## Memorandum

**Re:** Interstate 80/Gilman Street Interchange Improvement Project  
– Addendum to the Technical Reports  
District 04 - ALA - 80 - PostMiles 6.38 / 6.95  
EA 04-0A7700 / Project ID# 0400020155

### 1.1 ADDENDUM OF FIGURE REVISIONS

Figure 4-1: Socioeconomic Study Area

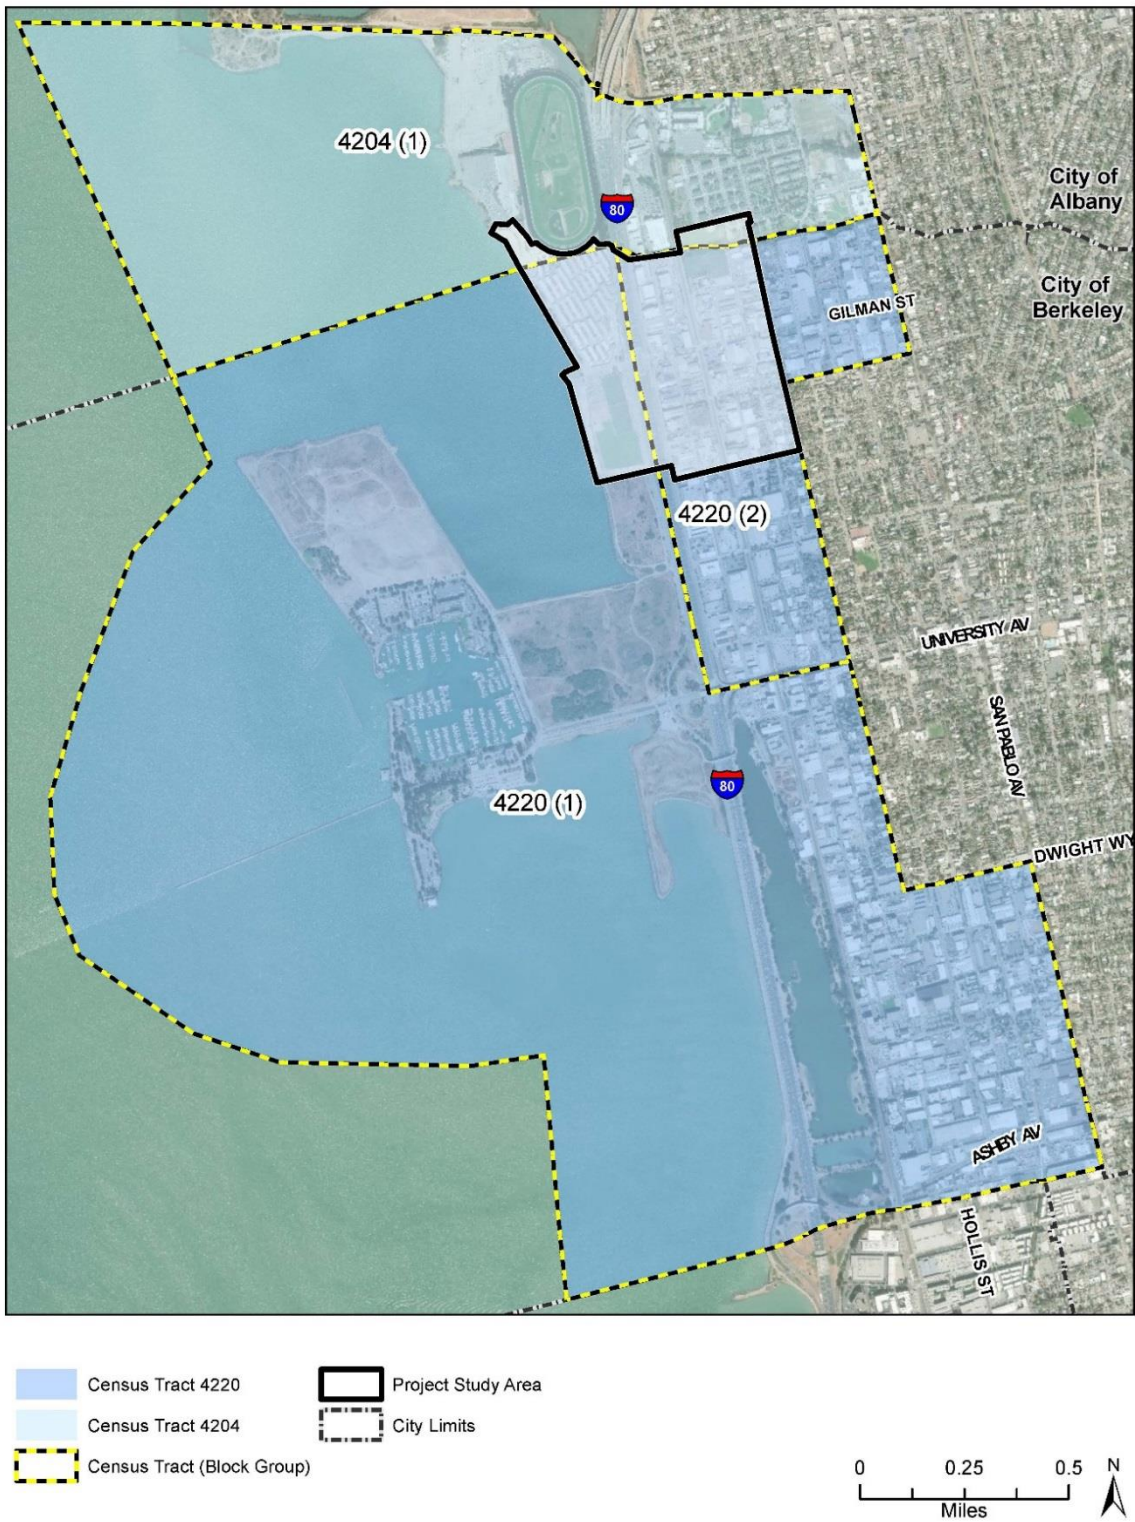
This addendum updates the project footprint and study area boundary depicted in various figures in the technical reports prepared for the Interstate 80 (I-80)/Gilman Street Interchange Improvement Project. This revision to the project footprint and study area boundary does not result in any change in the affected environment or potential impacts, and the findings presented in the previously approved technical reports remain valid. The technical reports, figure number, and figure name included in this addendum are identified below. The revised figures are attached at the end of this memorandum.

Figure 4-1: Socioeconomic Study Area

Figure 4-2: Community

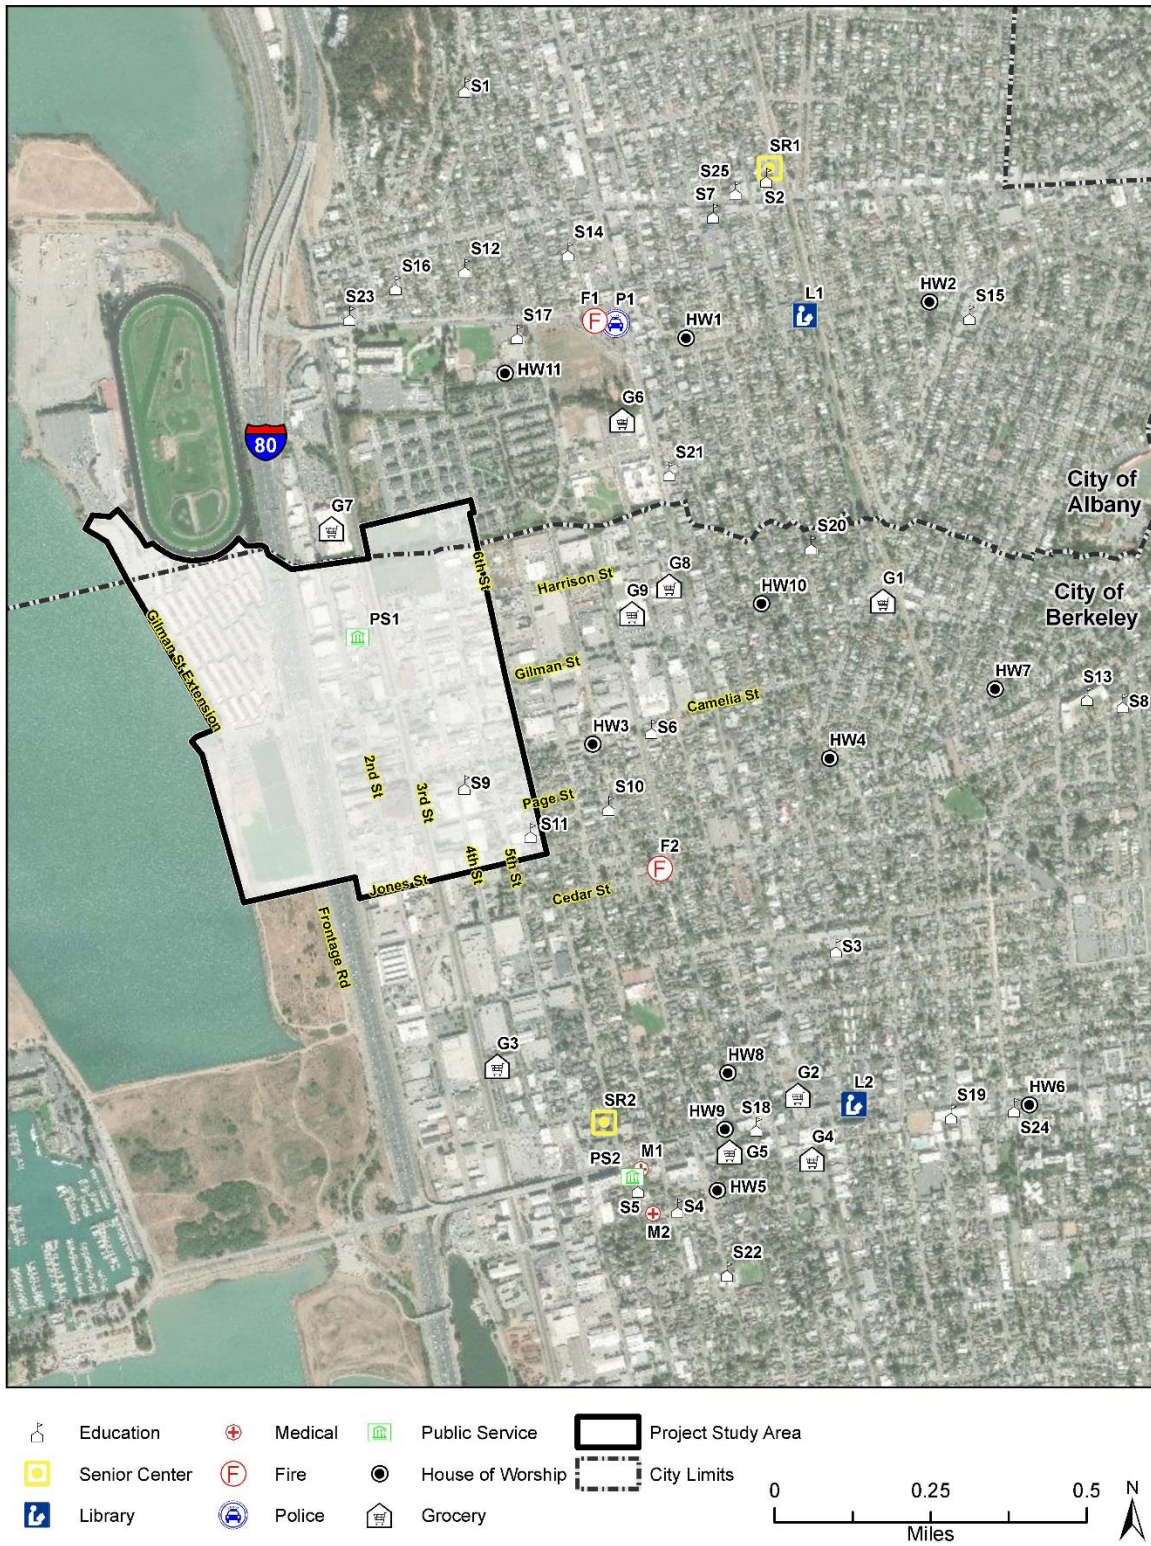
Figure 4-2: Community Facilities and Services

Figure 4-3: Proposed Property Acquisitions

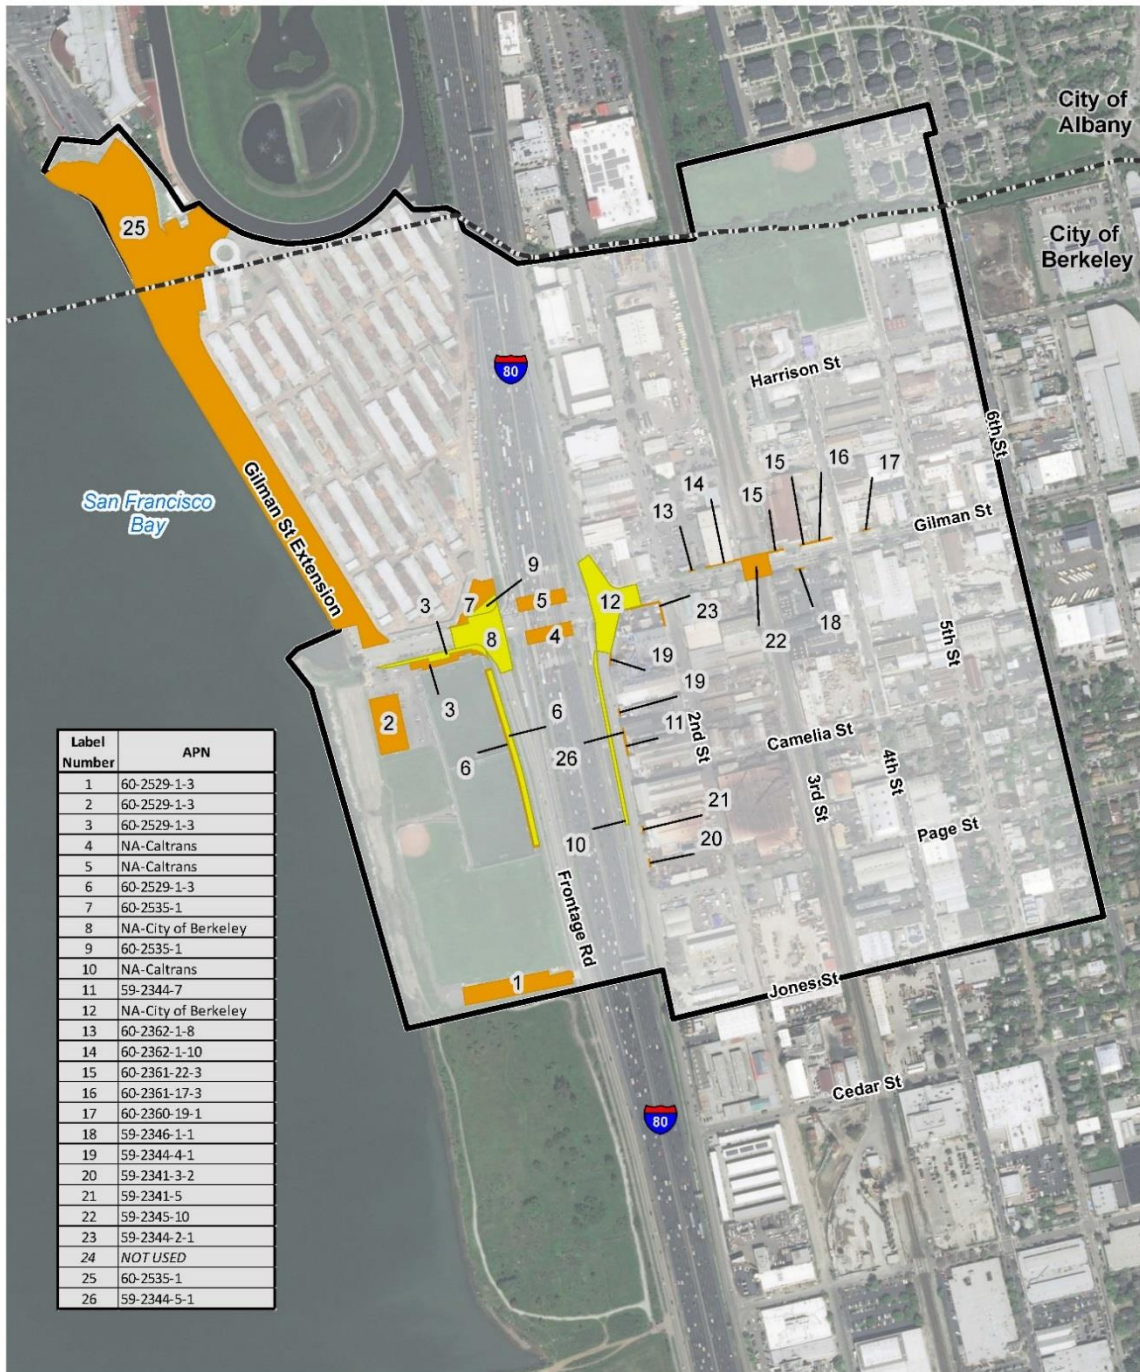
Figure 4-3: Proposed Property Acquisitions

Figure 5-1: Bicycle Routes and Pedestrian Facilities

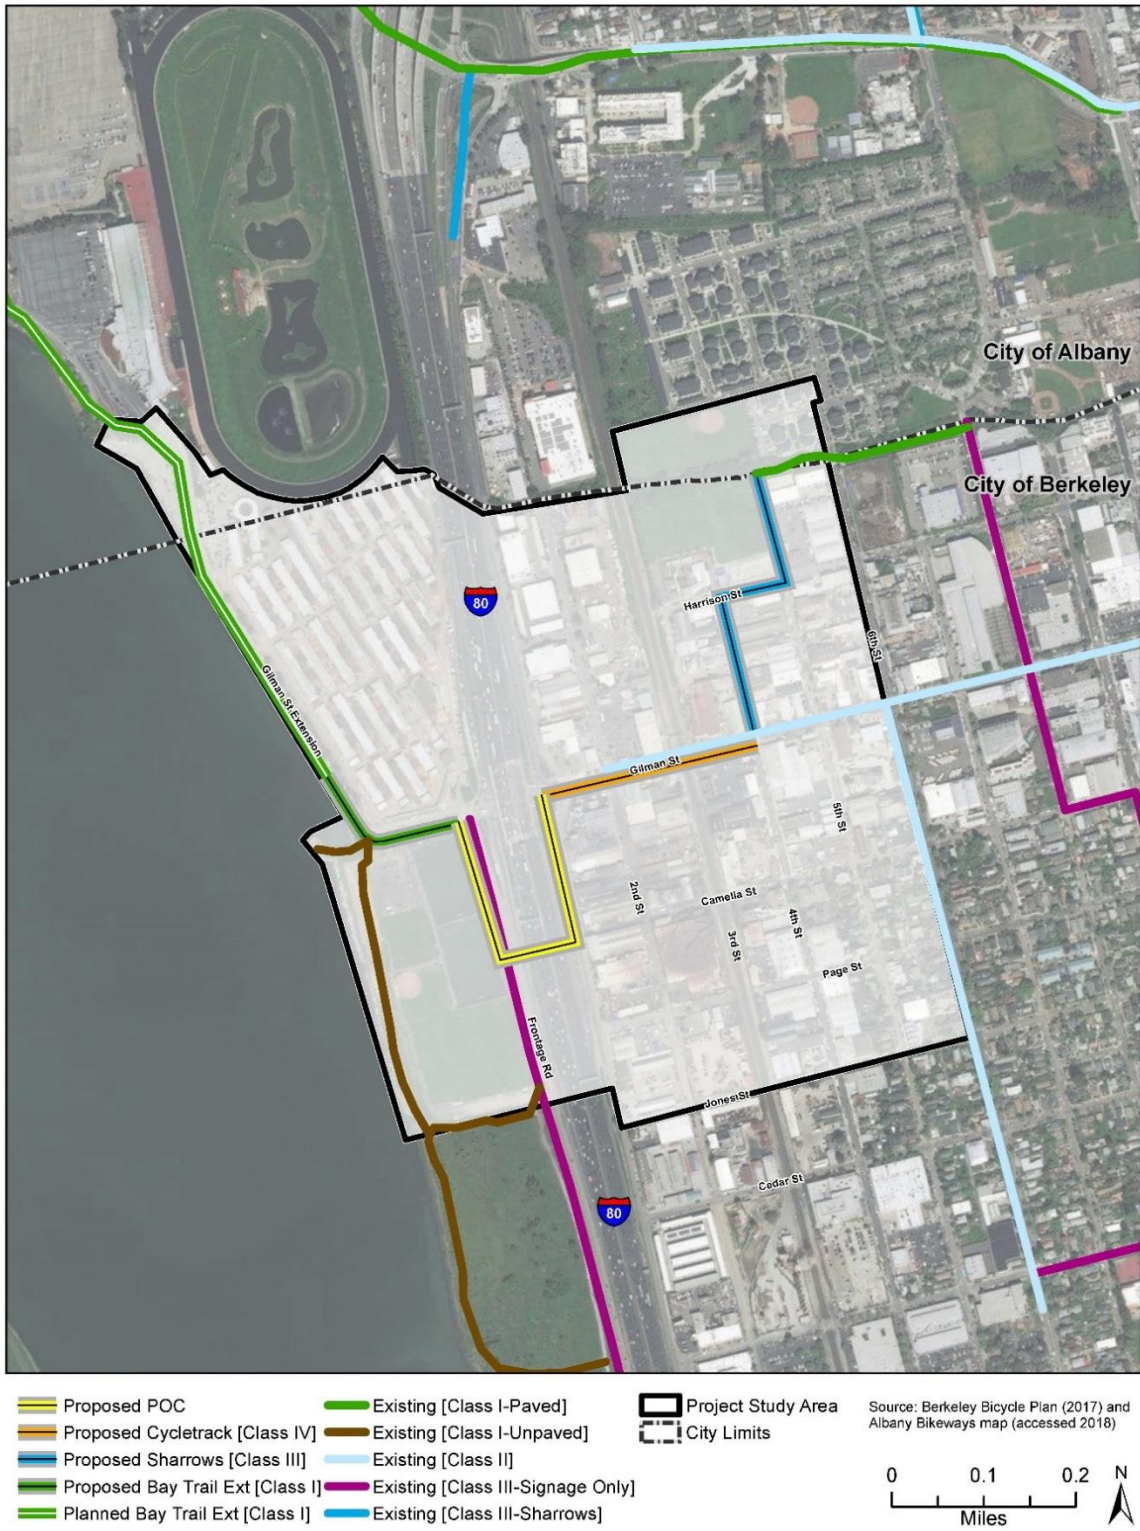
Figure 5-1: Bicycle Routes and Pedestrian Facilities

Figure 2: Project Location

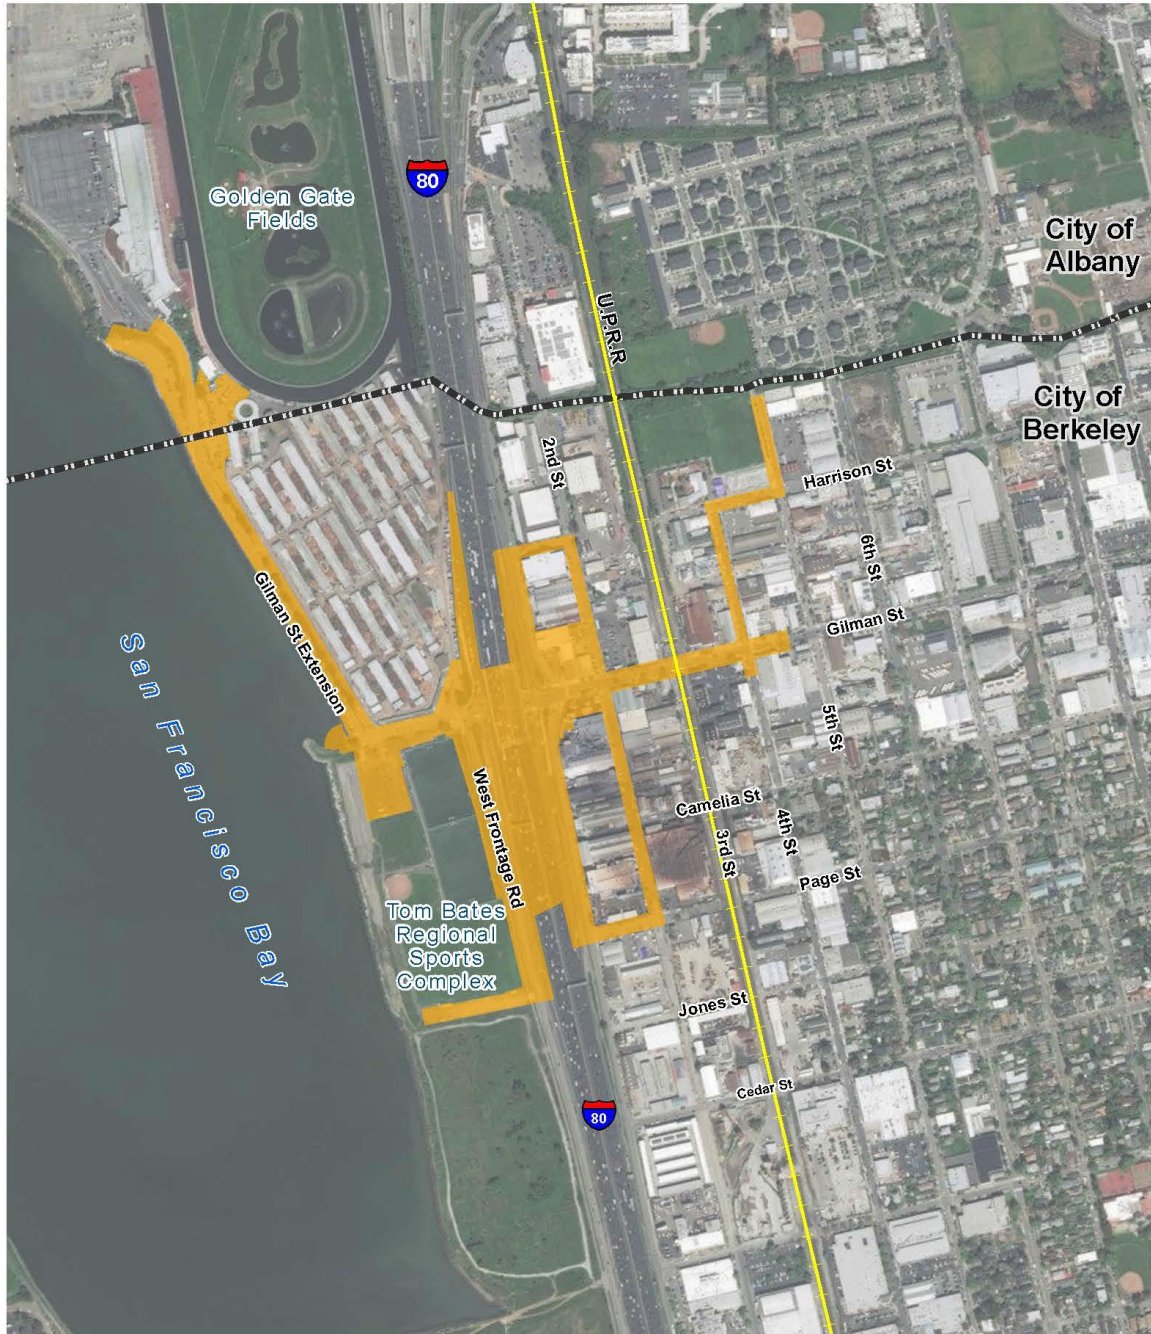
Figure 2: Project Location

Figure 4: Site Identifier Map

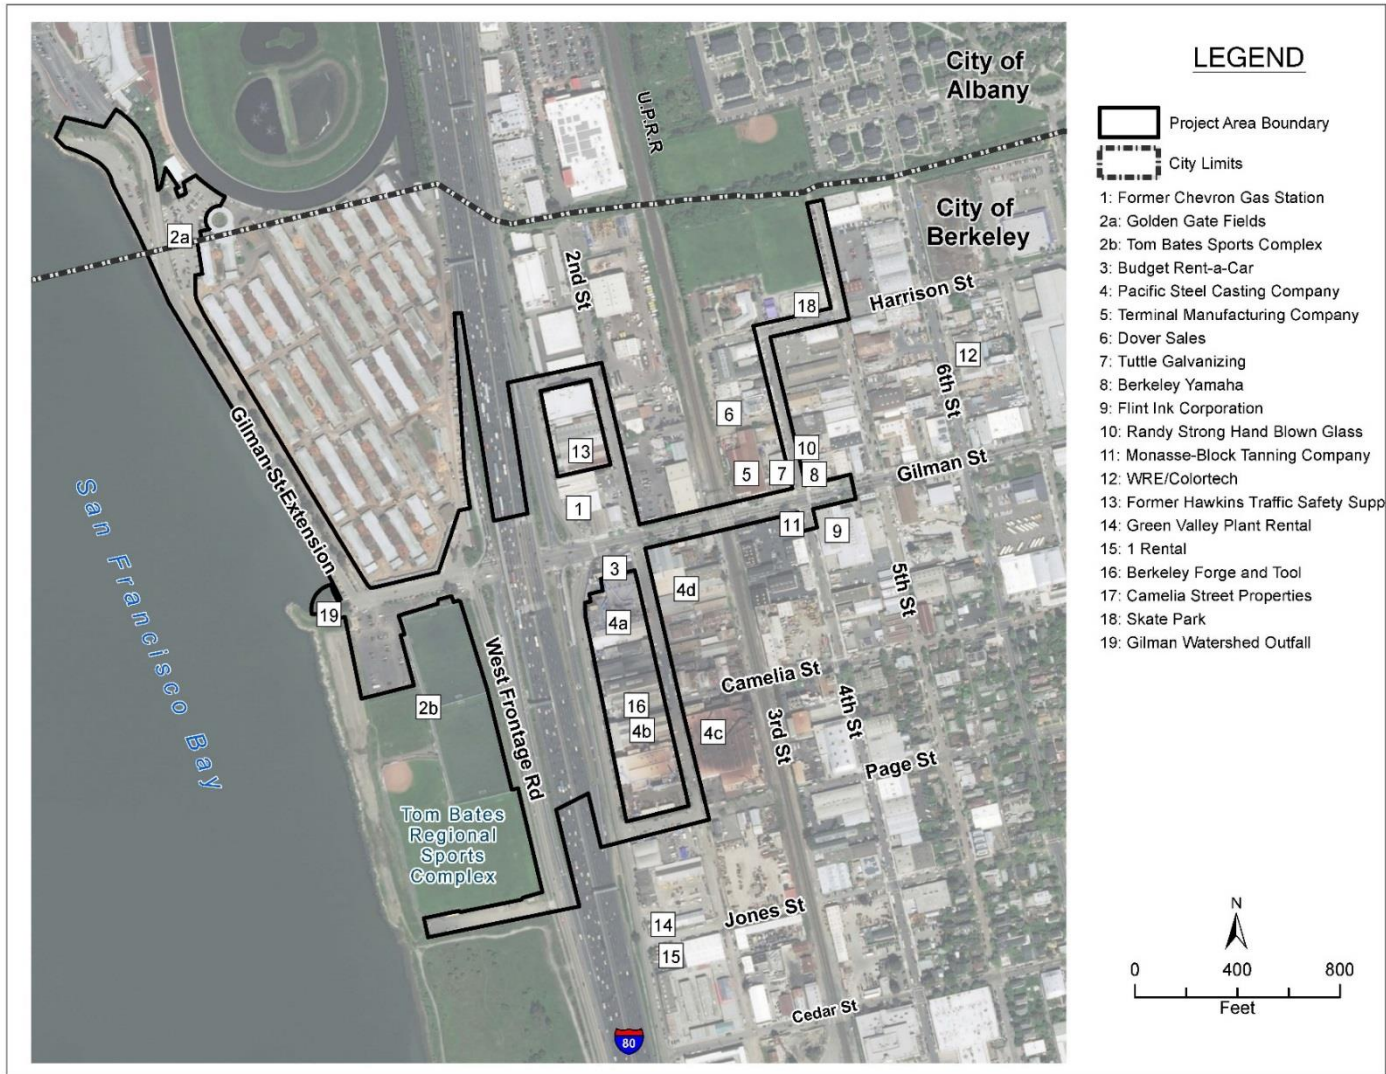
Figure 4: Site Identifier Map
